City of Sunnyvale

Memo

TO: Planning Commission
FROM: Mary Jeyaprakash, Project Planner
PROJECT: 800 Carlise Way Well and Water Tank Project (2022-0741) Response to Late Comments on EIR
AGENDA ITEM: 2
DATE: March 9, 2026

Proposed Site Plan

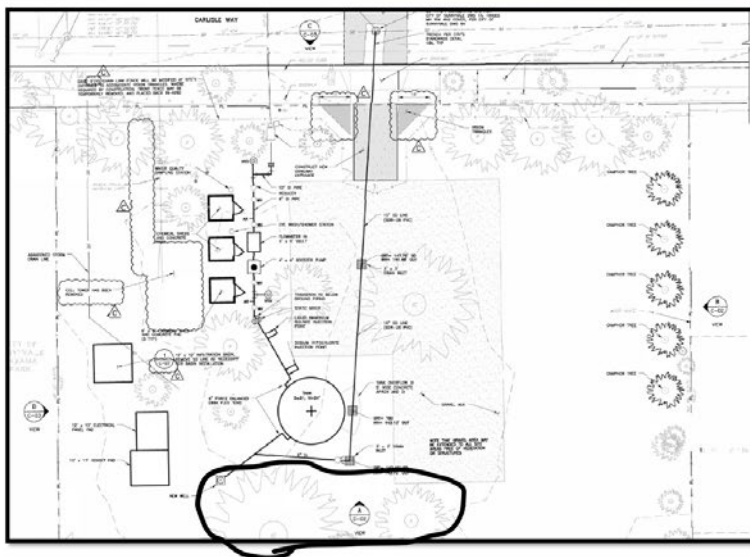
- **Unclear tree removal plans:** The current site plan includes a north elevation view (the view from coventry court residences) that shows all but perhaps one or two of the existing mature trees being removed along the southern boundary of the property. This is not shown on the arborist report of the site demolition plan.

Presentation to Planning Commission 5/27/25, comment says 8 trees to be removed (up from the prior 4) **but no**

This tree is also a nesting site for Coopers Hawks
